ADDENDUM NO. 1

**JACKSON ELEMENTARY SCHOOL RENOVATIONS
Valparaiso, IN 46304**

This Addendum consists of page ADD 1-1 and attached Addendum No. 1 from Gibraltar Design dated November 9, 2022 and consisting of 4 pages and 29 drawings.

Addendum One (AD.01) to the drawings and specifications prepared by Gibraltar Design for **Jackson Elementary School Renovations** for Duneland School Corporation, Chesterton, Indiana.

© GIBALTAR DESIGN	SHEET
A	MP101

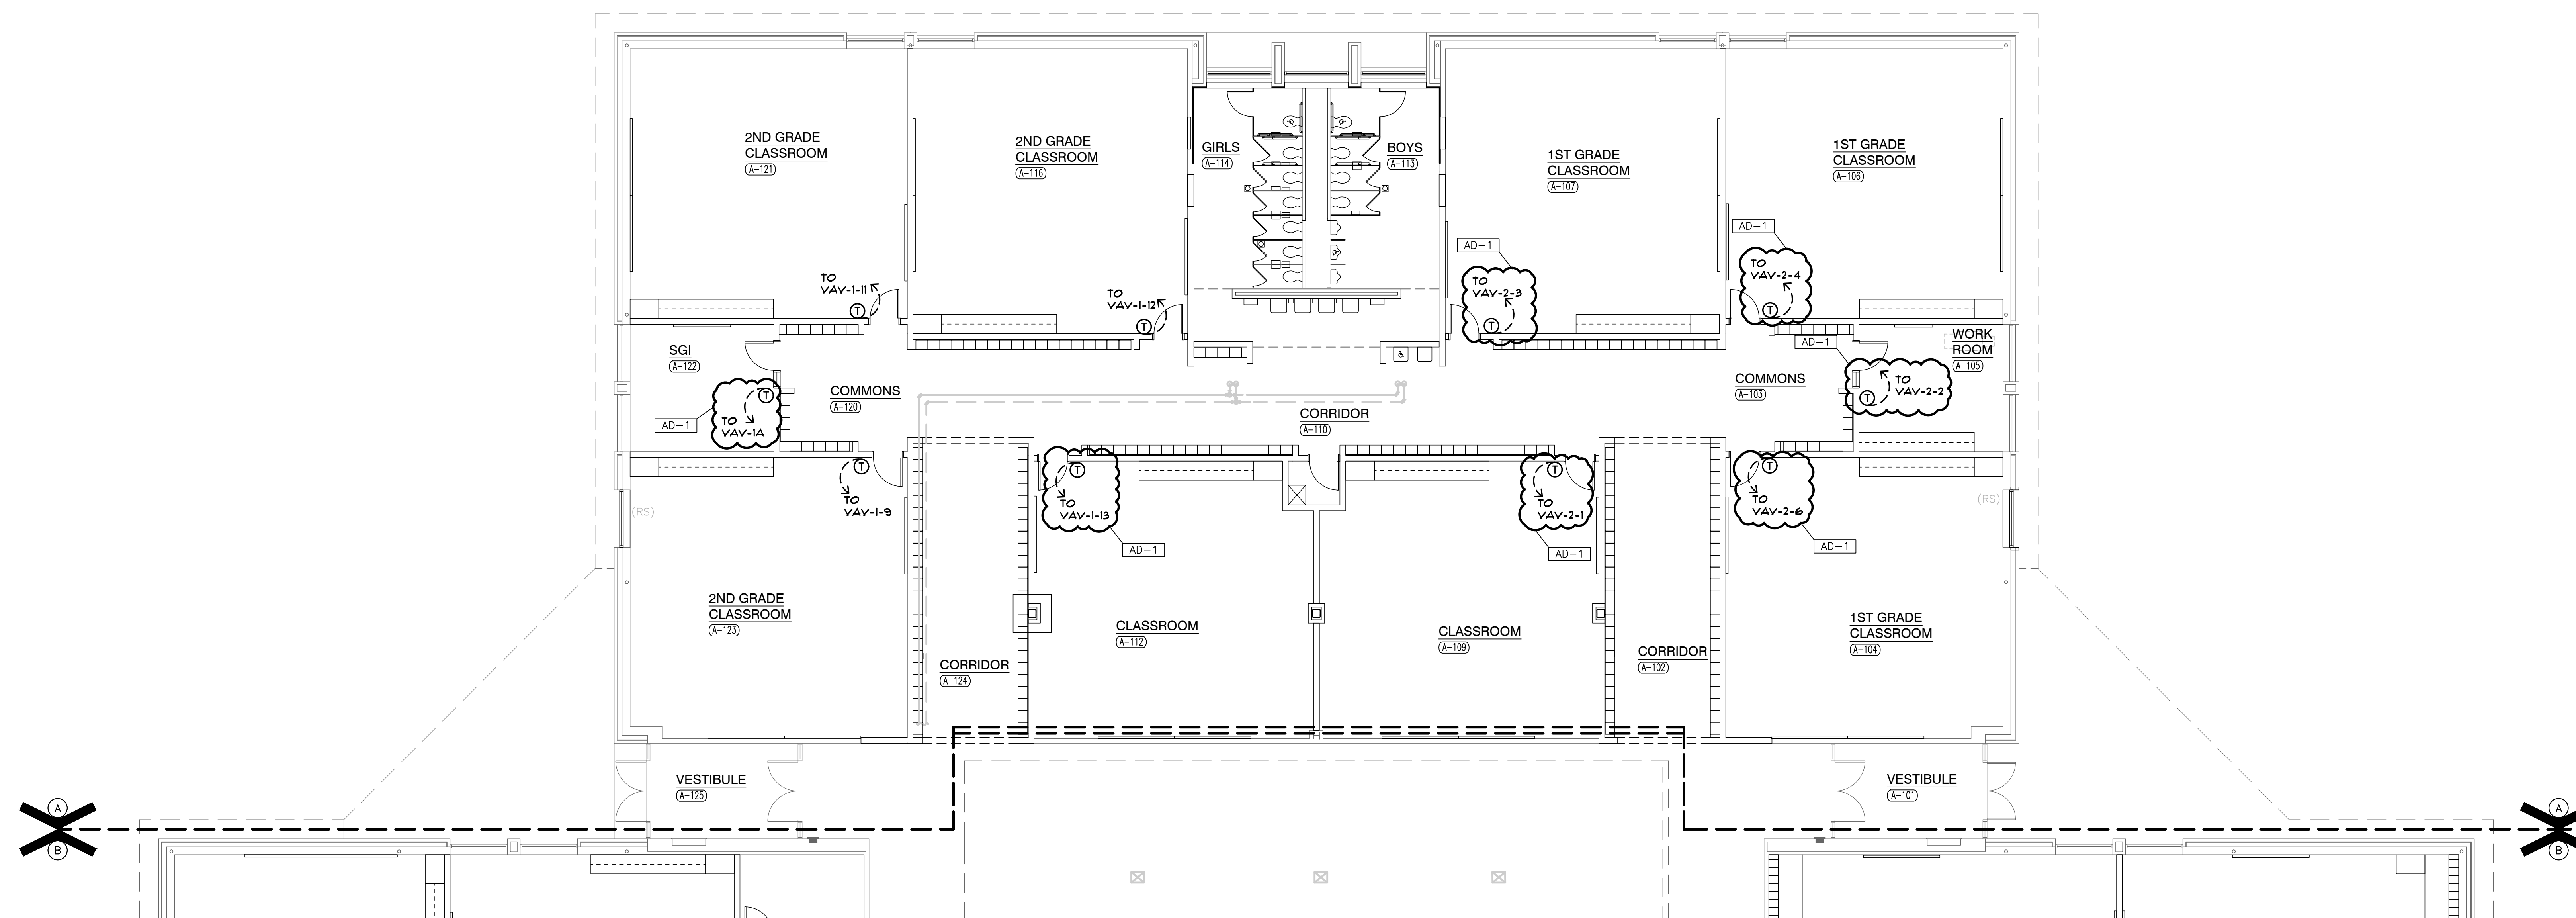
18. Sheet MP101

- A. Refer to revised full size drawing, included in this Addendum, for the following revisions:
 1. Clarified thermostat connection to equipment.

EP104

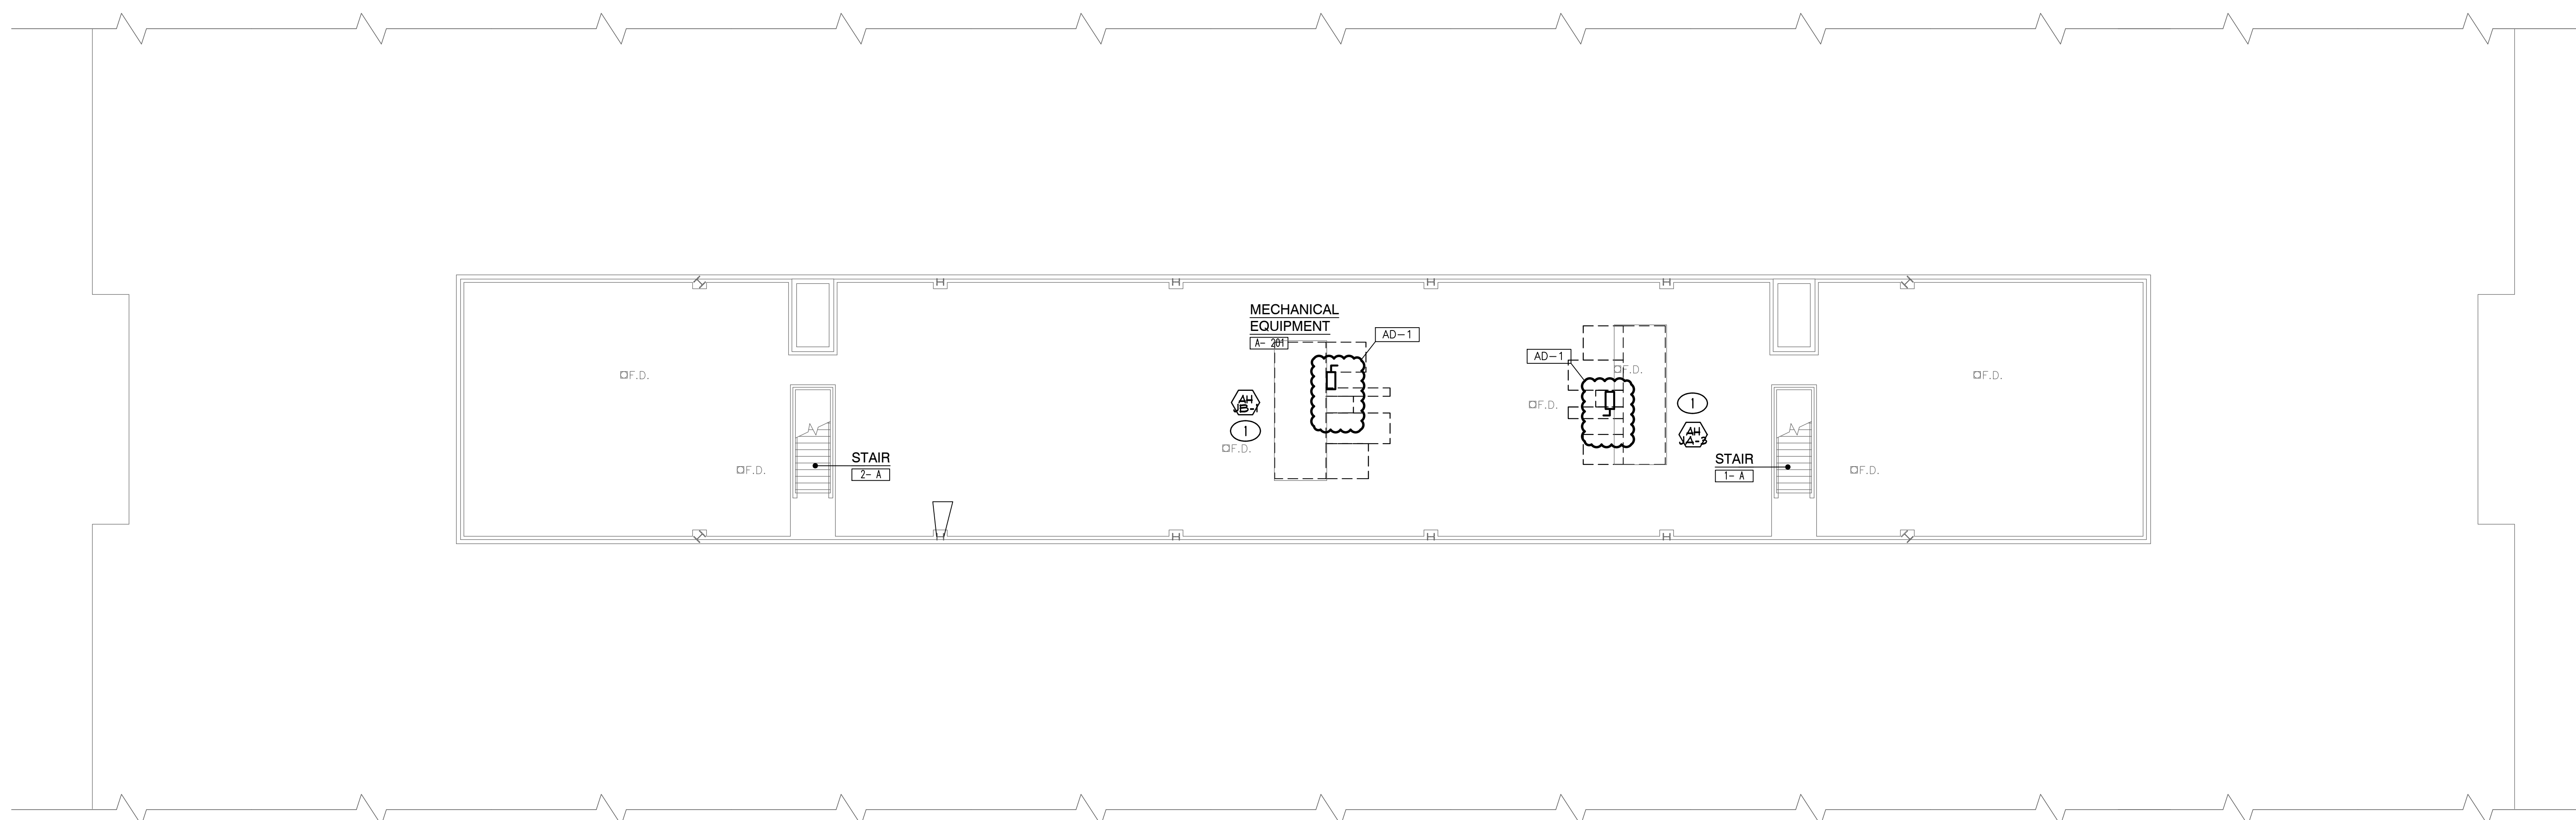
25. Sheet EP-104

- A. Refer to revised full size drawing, included in this Addendum, for the following revisions:
1. Added electrical connections to AHJB1 in Mechanical A-201.
 2. Added electrical connections to AHJB3 in Mechanical A-201.
